**Exhibition of Environmental Assessment for Mixed Commercial and Retail Development (Stage 1) at 2 Australia Avenue, Sydney Olympic Park (Site 43/44) (MP10\_0168)**

**Attach. A1.**  
 SOPA markup  
 Alternative ramp  
 locations and  
 envelope changes  
 Jan. 2012.

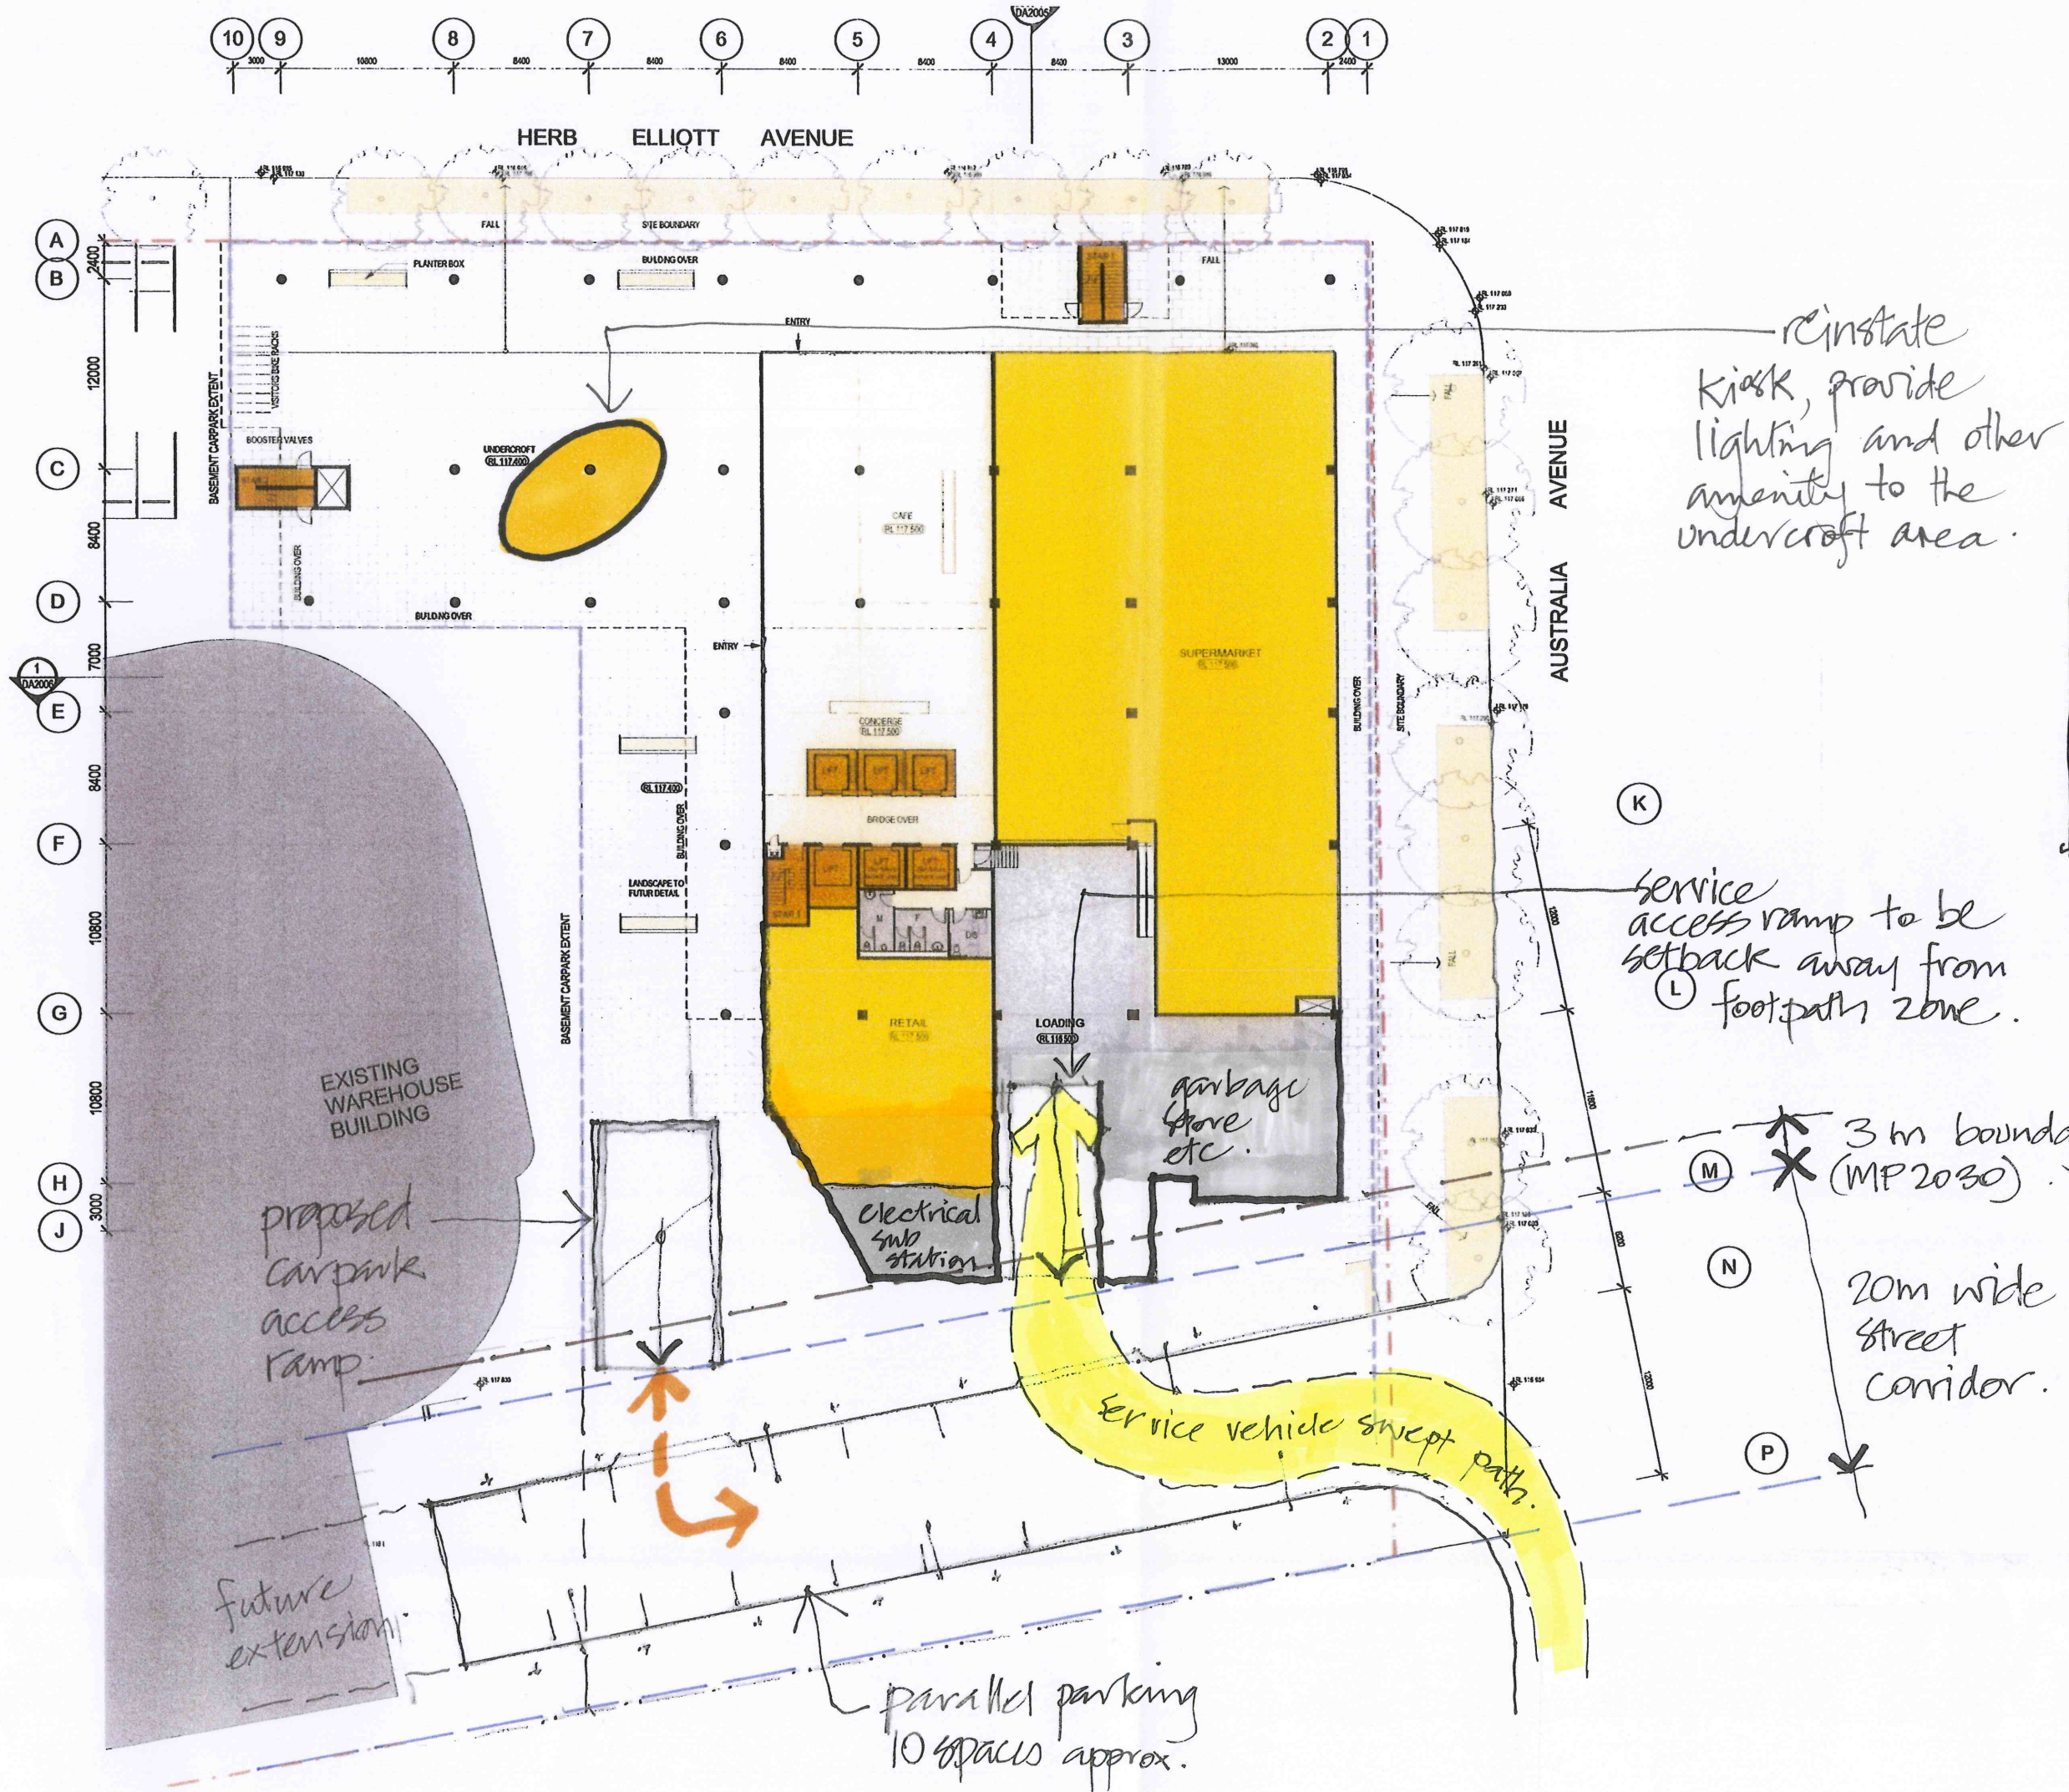
4. The electrical services kiosk is to be integrated into the building envelope, as in the design competition proposal. Freestanding electrical infrastructure is not suitable for the Town Centre public domain, especially sites with such high visibility. Refer to sketch in Attachment A1. To date external kiosks have not been allowed for new developments in street front locations in the town centre.

5. The basement car park access ramp should be located away from the future street corridor, refer to suggested alternative in attachments A1 and A2. This is discussed in further detail below.

6. The service vehicle entry ramp is to be relocated away from the footpath to ensure that the ramp incline/decline commences clear of the public footpath, refer to suggested alternative in attachments A1 and A2. This may impact on height clearances and upper level setbacks will need to be reconsidered. The ramp relocation will also affect loading dock turning circles and adjustments to this area will be required.

reinstall  
 kiosk, provide  
 lighting and other  
 amenity to the  
 undercroft area.

service  
 access ramp to be  
 setback away from  
 (L) footpath zone.

3m boundary setback.  
 (MP 2030)

20m wide  
 street  
 corridor.

parallel parking  
 10 spaces approx.

Attach. A2.  
SOPA Markup.  
Alternative Ramp  
Location.  
Jan 2012.

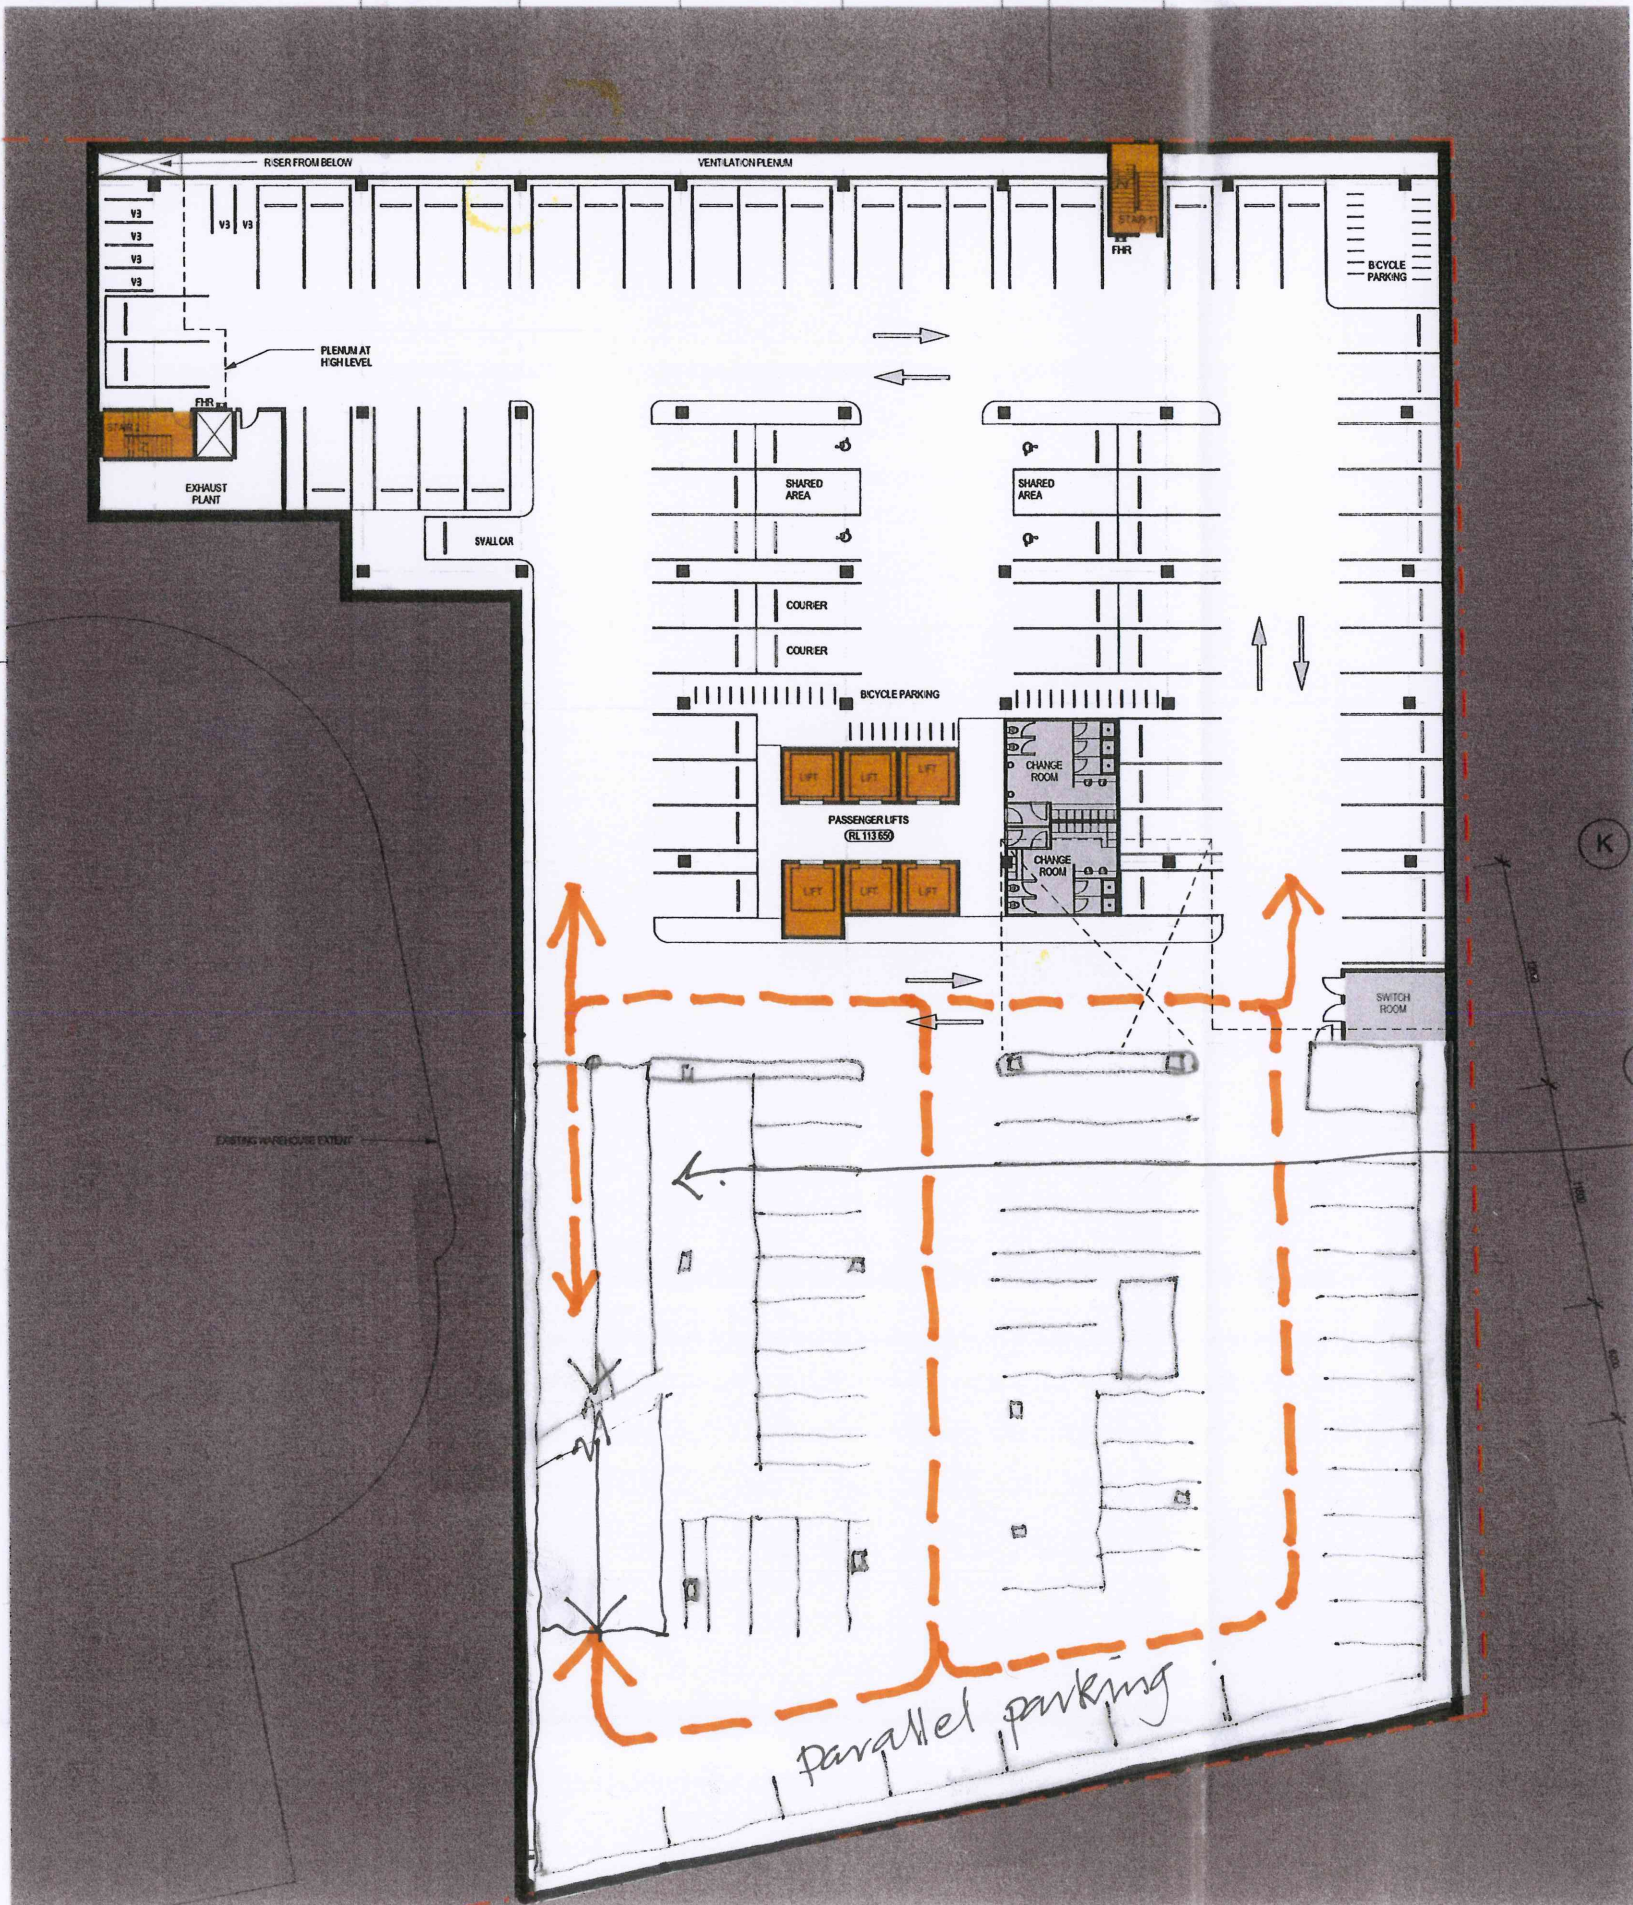
The proposed placement of the temporary ramp for basement parking has a number of shortcomings, especially in relation to the construction of New Road 10 and any vehicular access to adjacent development sites. It is recommended that the temporary ramp be relocated to an area outside the footprint of any proposed new road, refer to suggested alternative in attachments A1 and A2

1. The proposed basement access ramp is to be relocated out of the proposed new road 10. The current location provides an unacceptable level of conflict between vehicles in three directions and has the potential to limit the ability to realise the future extension/creation of new road 10. Sketches have been provided at Appendix A1 and A2 that demonstrate one option for the relocation of the vehicle access ramp.

proposed  
ramp relocated.
